U.S. Department
Of Transportation
**Federal Highway
Administration**

Refer to: HNG-21/SS-01A

This is in response to your June 9 letter requesting Federal Highway Administration (FHWA) acceptance of two-post installations of certain sizes of your company's Type "A" Small Sign Support System for use on Federal-aid highway projects. You enclosed a copy of a POZ-LOC Anchor System brochure and a Southwest Research Institute Report No. 06-1120-001 dated May 1986 containing full-scale crash test information.

SMALL SIGN SUPPORT DETAILS

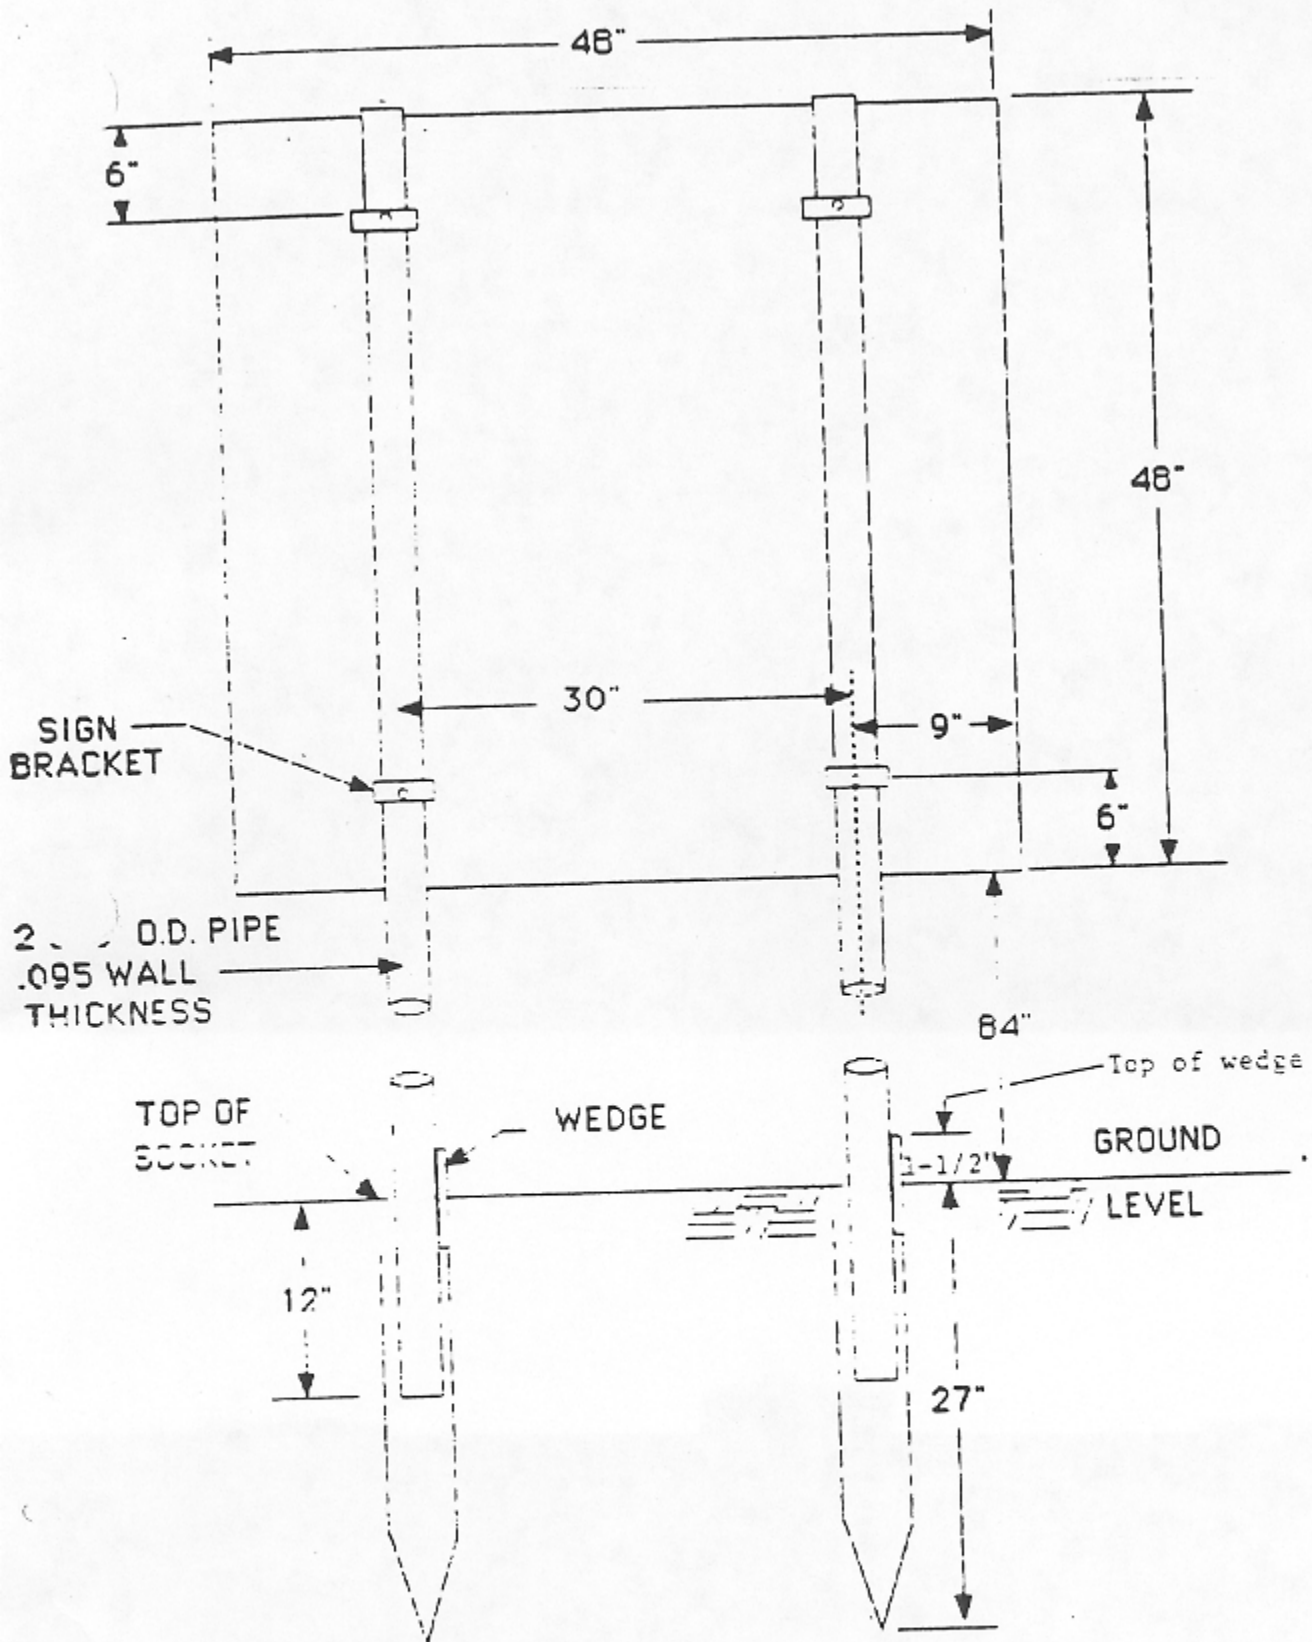
You have now conducted an additional test of the 2 3/8-inch O.D. 13 gauge (.095) sign post where two posts were impacted. The tested system consisted of separate 2 7/8-inch O.D. by .109 galvanized tubular sockets that were driven into soil meeting the National Cooperative Highway Research Program (NCHRP) Report No. 230 strong soil (S01) criteria. Separate 2 3/8-inch O.D. 13 gauge signposts were inserted into the sockets and the posts locked into position with 2 7/8-inch by 2 3/8-inch x 11 gauge post wedges. Enclosed is a figure showing the sign support details. The full-scale test was conducted with a 1,850-pound vehicle impacting the two-post installation at 20.6 m.p.h. Reported test results, using the average of the film and accelerometer data, indicate a change of velocity of 14.8 feet/second. These translate to a change of momentum of 859 pound/seconds. Also, we concur with your assessment that the two-post installation is acceptable under high speed (60 m.p.h.) impacts based on previous testing. Therefore, the tested system meets the provisions of the new, but yet unpublished, 1985 American Association of State Highway and Transportation Officials (AASHTO) "Standard Specifications for Structural Supports for Highway Signs, Luminaires and Traffic Signals". We also infer this system meets the 1975 AASHTO specification since the 1985 AASHTO specification is more demanding.

Based on the above, your tested system is acceptable for use on Federal-aid projects if proposed by a State. Also, we infer that your POZ-LOC anchor systems comprised of the same socket, wedge, and post O.D. as the tested system, only the posts have thinner wall thicknesses of .080 and .065, are also acceptable when two posts are used within an 8-foot path.

We note your system was only tested in the S-1 strong soil described in NCHRP Report No. 230. If you desire to use this system in soil equivalent to the S-2 soil described in NCHRP Report No. 230, we recommend additional tests be conducted in that soil type.

This acceptance is limited to breakaway characteristics of the system described above and does not cover its structural features. Presumably, Southwestern Pipe, Inc., will supply potential users with sufficient information on structural design and installation requirements, including the need to size the sign panel and support for expected wind loading, to ensure proper support performance.
